# Access Compliance Report

## Public Rights-of-Way

Intersection ID: 47971	Main Street: SOUTH_CREEK_RD	Cross Street: KYRENE_RD	Location: N
ADA ID: E3A6D49D991D	Ramp Type: PerpDiag	Initial Pass/Fail: Fail	Overall Compliance: No
Severity Score: 8.75			
Codes/Mitigation Info/Possible Solution		Field Measurements/Component Compliance

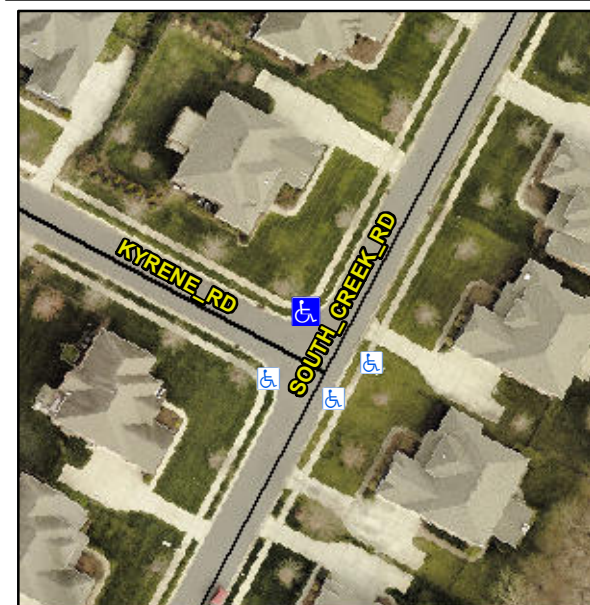
**Remove & Replace Curb Ramp With Two New Directional Ramps or Equivalent.**

**Not Found, R304.5.1**
